TECHNICAL BULLETIN
Bell Helicopter **TEXTRON**

No. 407-02-38

MODEL AFFECTED: 407

SUBJECT: TAIL ROTOR CONTROLS ANTI-CHAFFING
PACKING, ADDITION OF.

Figure 3. Chafing protection of 406-001-704 Bellcrank

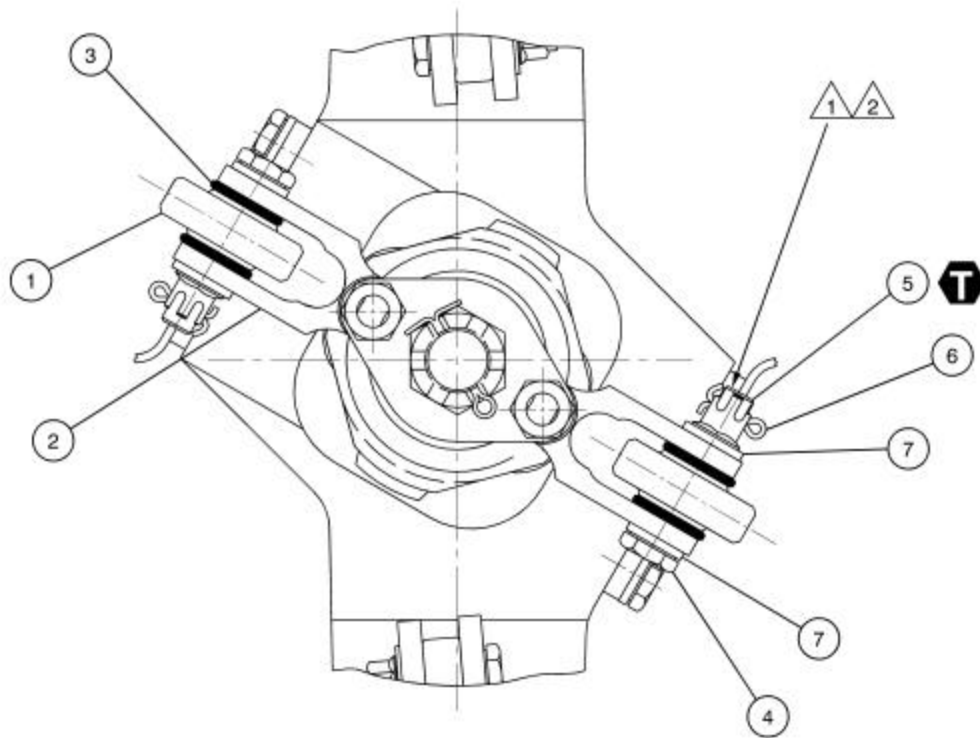
7. Install one packing -013 (3) between bellcrank (1) and control tube rod end bearing (2).
8. Reinstall control tube (2) to bellcrank (1) using C-104 on bolt (4) shank.
9. Install washer (7) nut (5) and cotter pin (6). 
10. Install the tail rotor gearbox fairing (refer to chapter 53 of the Maintenance Manual).
11. Make an entry in the helicopter record logbook to show that Part II of this Technical Bulletin is completed.

Figure 1. Chafing protection of Crosshead

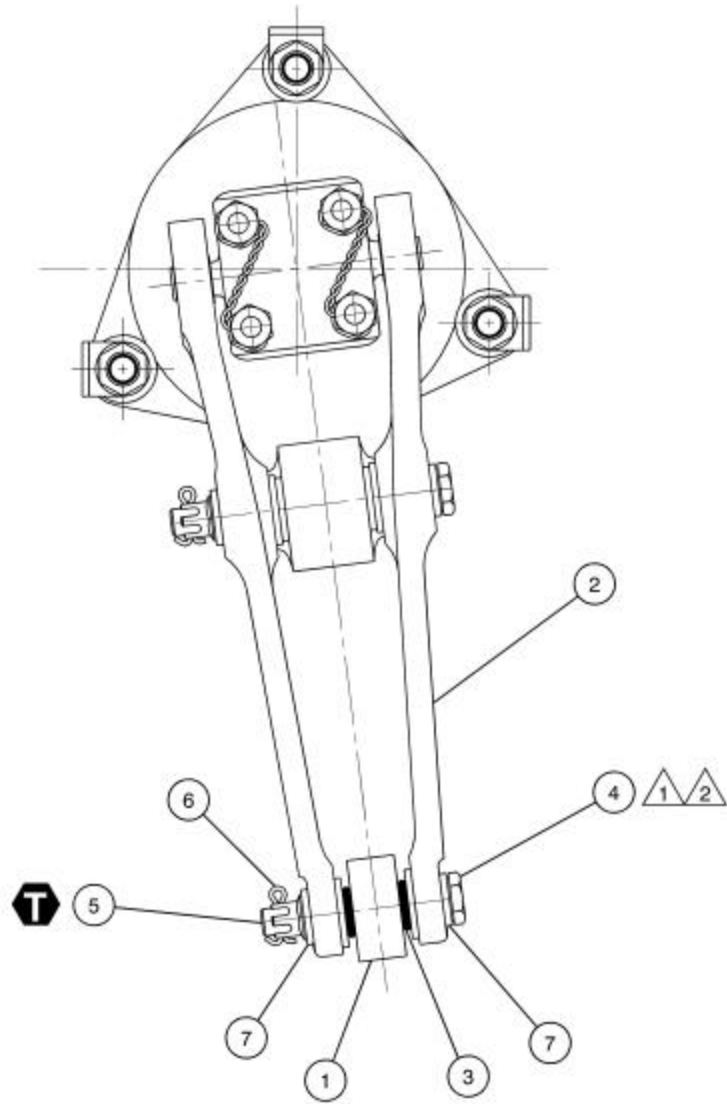
PART 1: Installation of packing to prevent chafing damage of 407-012-109-crosshead

1. Disconnect tail rotor pitch links (1, figure 1) from tail rotor crosshead (2).
2. Install one packing -014 (3), on each side of the pitch links spherical bearings
3. Reinstall pitch links (1) washers (7), and bolts (4) on crosshead (2) using C-104 on bolt (4) shank. Do not apply C-104 to threads.
4. Install washers (7), nut (5), and cotter pin (6) 
5. Make an entry in the helicopter record log book to show that Part 1 of this bulletin is completed.

Figure 2. Chafing protection of 407-001-732 Bellcrank

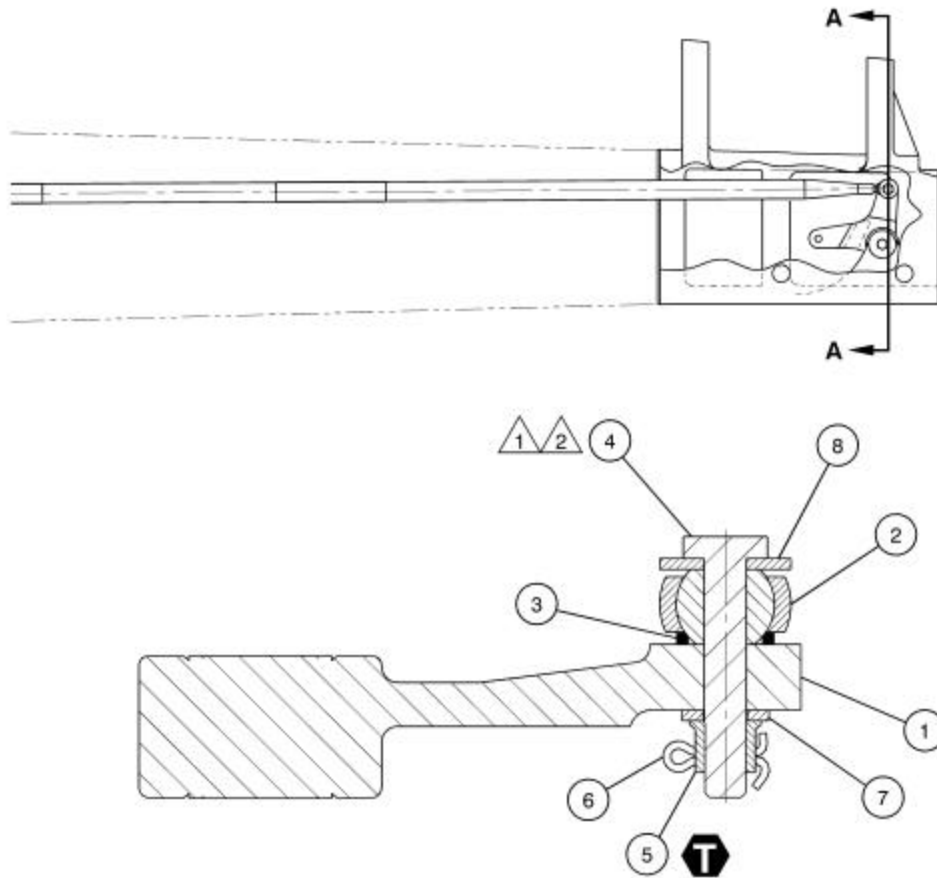
PART II: Installation of packing to prevent chafing damage of 407-001-732 or 406-001-704 bellcrank.

1. Remove tail rotor gearbox fairing (refer to chapter 53 of the Maintenance Manual).
2. Disconnect link (1, figure 2) from lever assembly (2).
3. Install one packing -013 (3), on each side of link (1) spherical bearing.
4. Reinstall link (1) washer (7), and bolt (4) to lever using C-104 on bolt (4) shank. Do not apply C-104 to threads.
5. Install washer (7), nut (5), and cotter pin (6) 
6. Disconnect control tube (2, figure 3) from bellcrank (1).
